WESTINGHOUSE NUCLEAR SAFETY
SAFETY EVALUATION CHECK LIST

- 1) NUCLEAR PLANT(S) : BYRON/BRAIDWOOD UNITS 1 & 2
- 2) SUBJECT (TITLE): RELAXATION OF MSSV SETPOINT TOLERANCE TO +/-3%

BYRON/BRAIDWOOD UNITS 1 AND 2
INCREASED MAIN STEAM SAFETY VALVE SETPOINT TOLERANCE
SAFETY EVALUATION

FIGURE 15.2-3

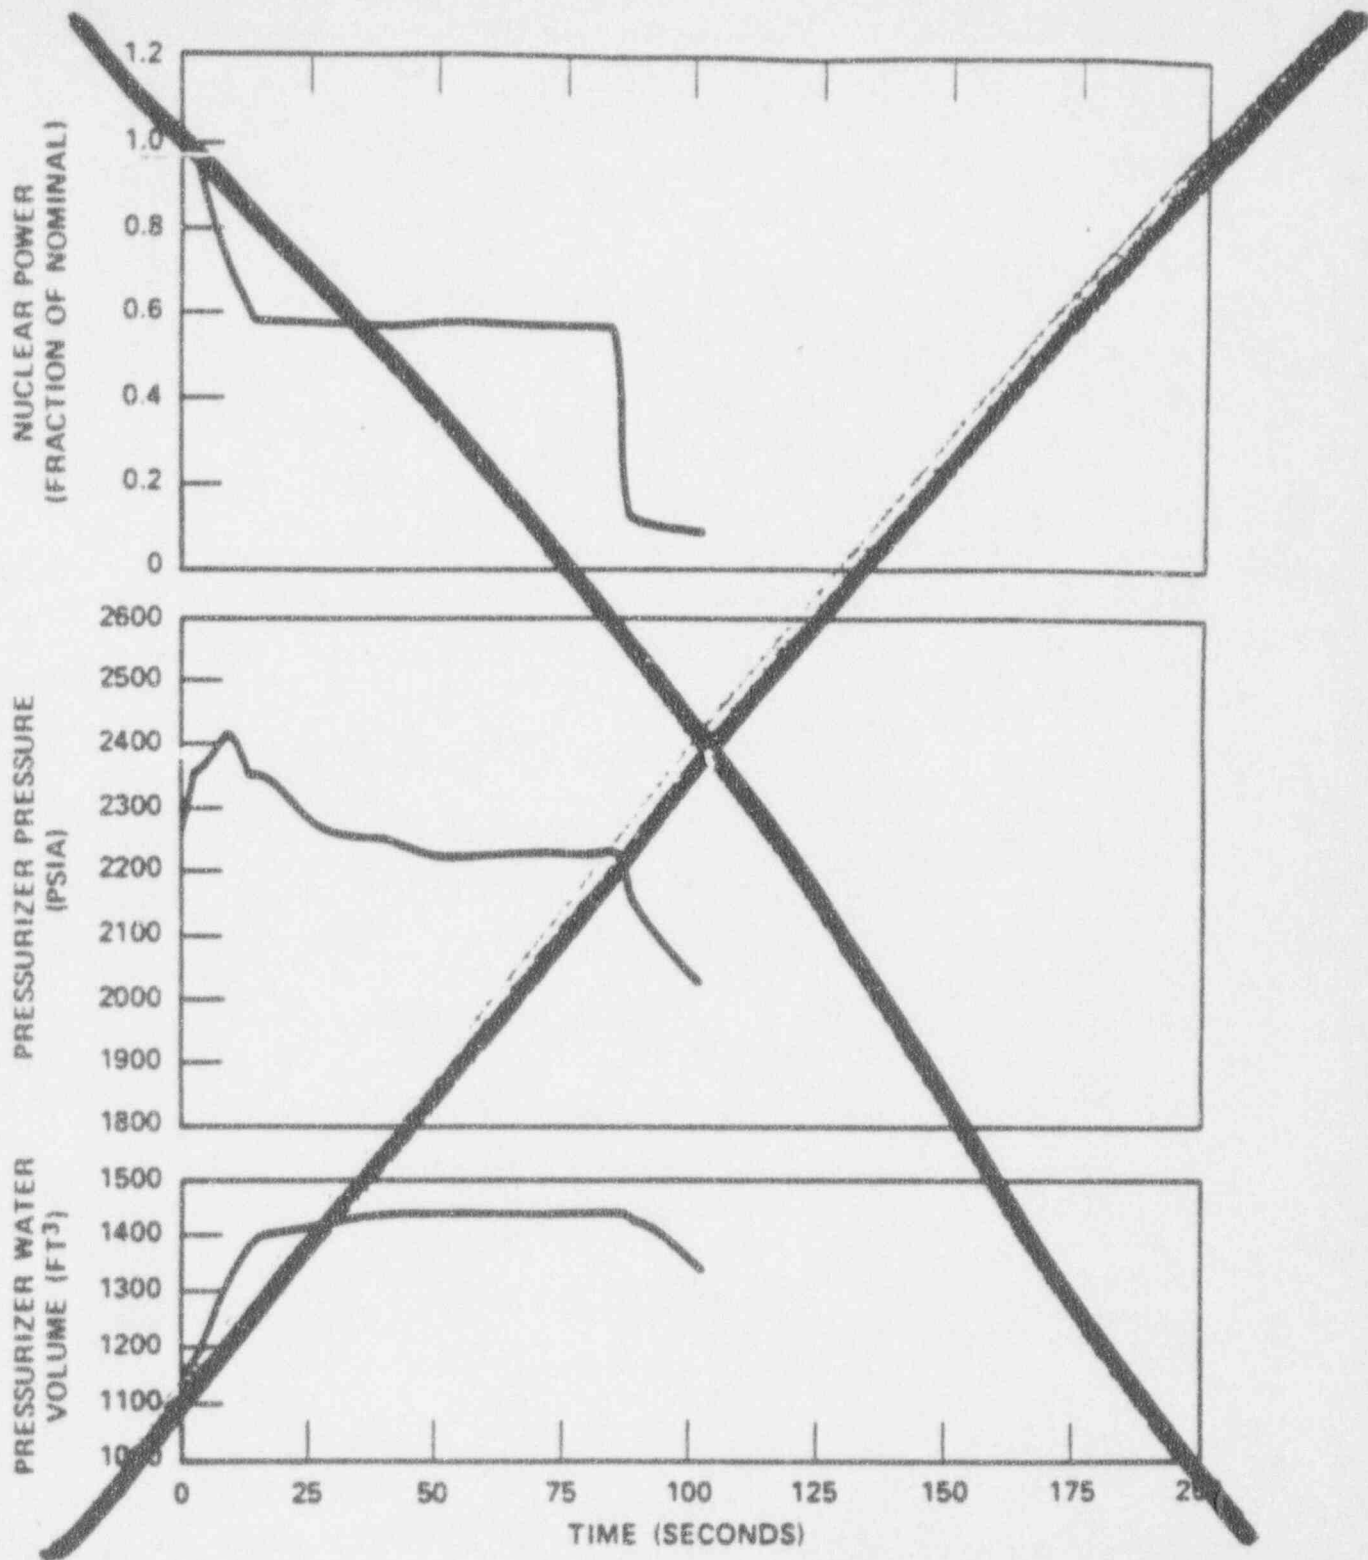
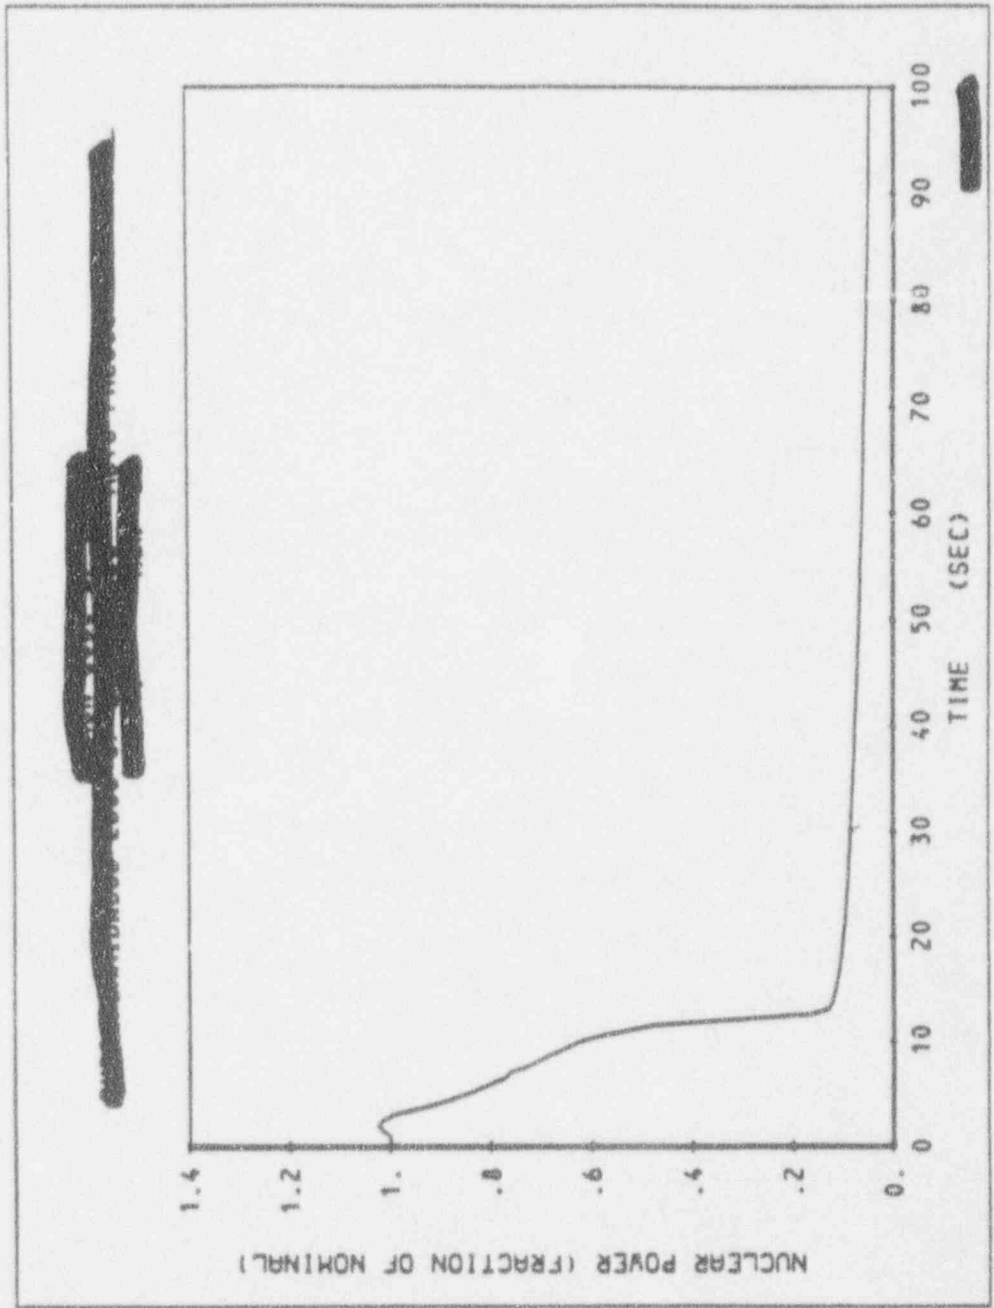
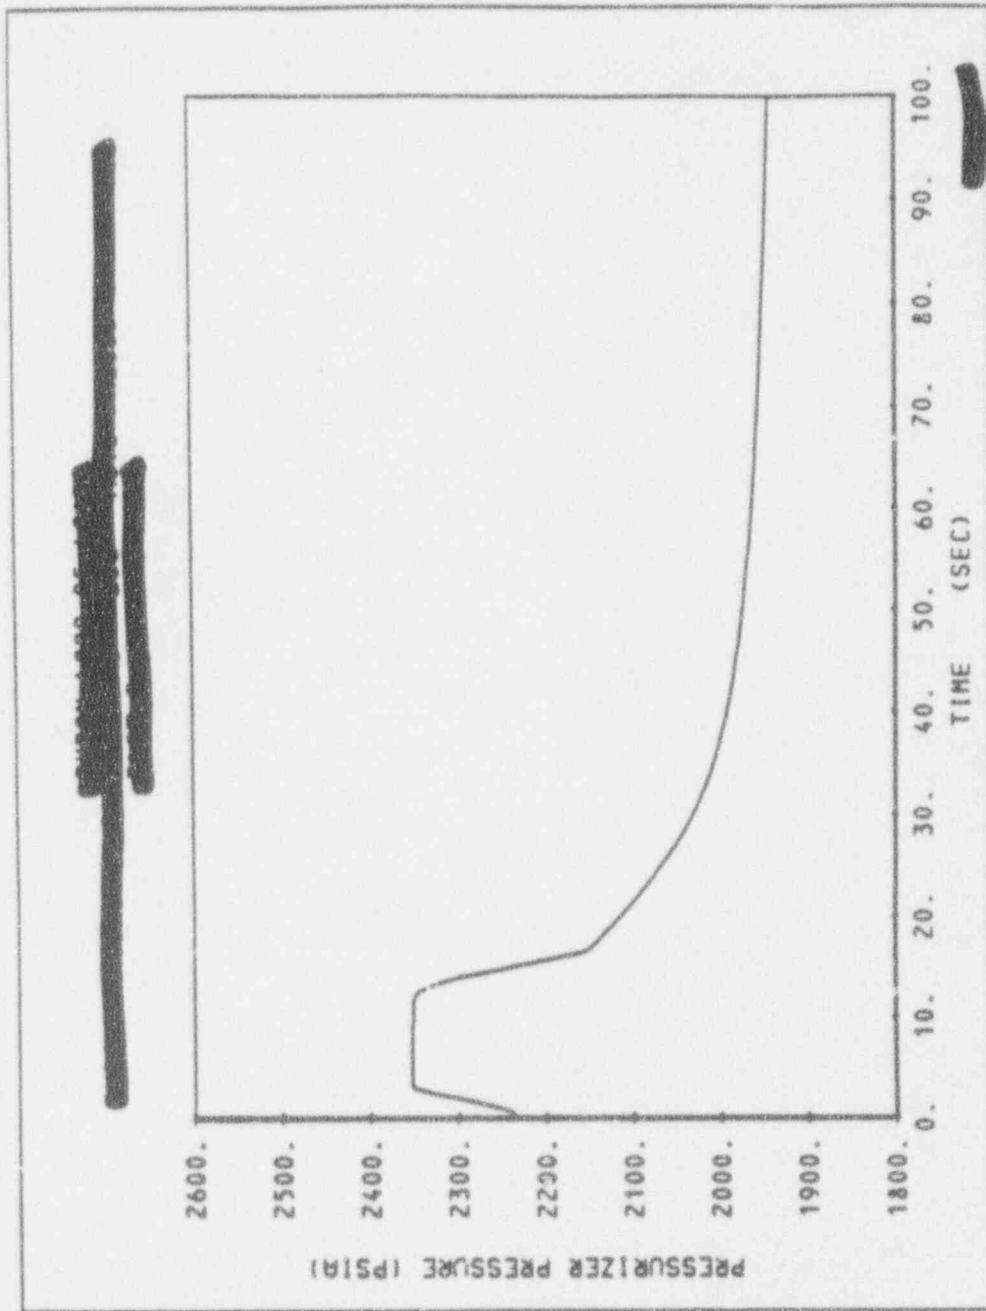
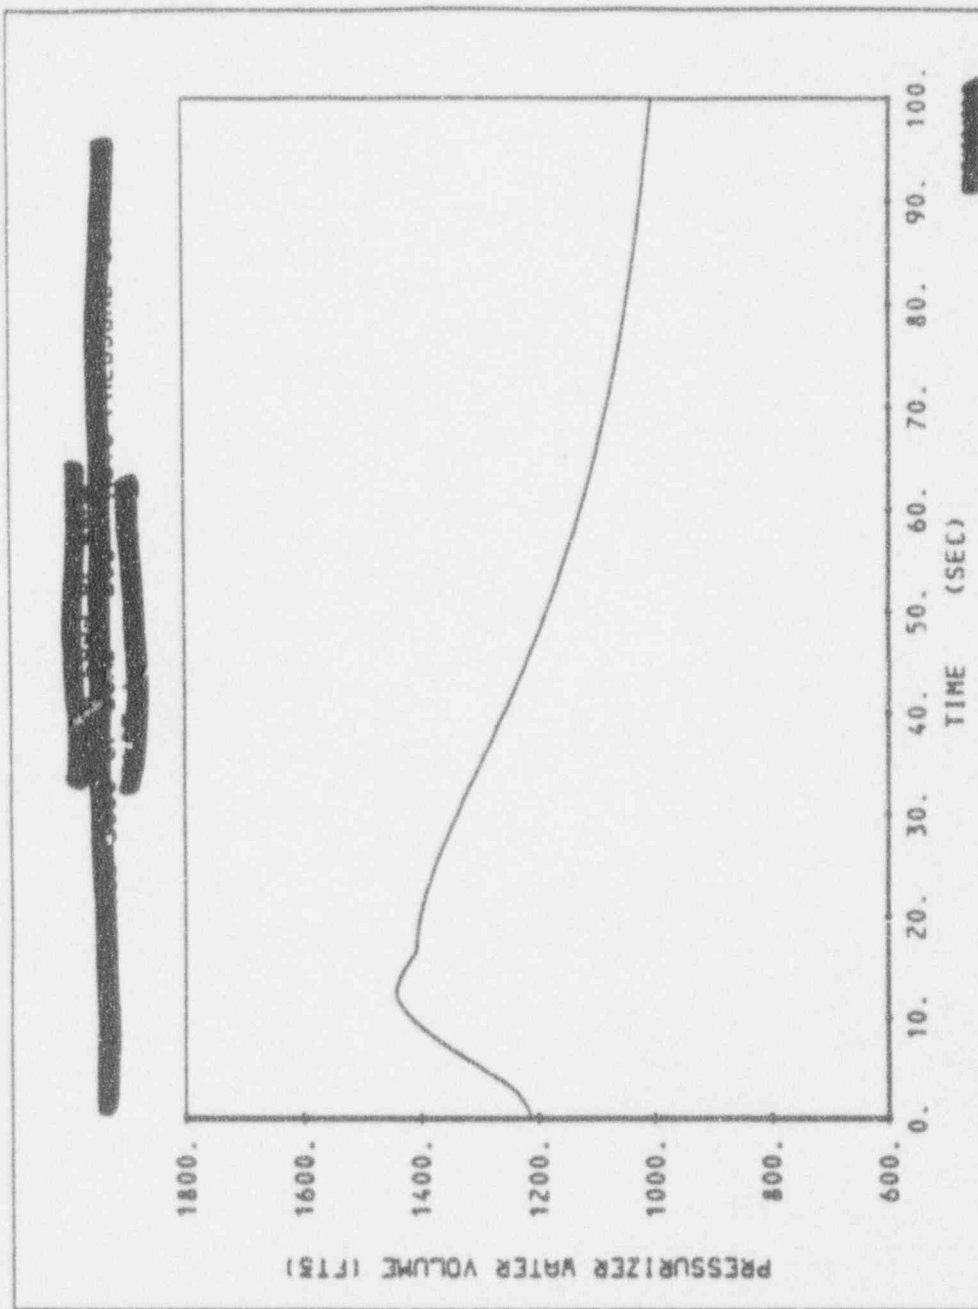
Figures 15.2-3 and 15.2-4 show the response for the total loss of steam load with a large negative moderator temperature coefficient. All other plant parameters are the same as the above. The DNBR increases throughout the transient and never drops below its initial value. Pressurizer relief valves and steam generator

REPLACE WITH
the following
Figures
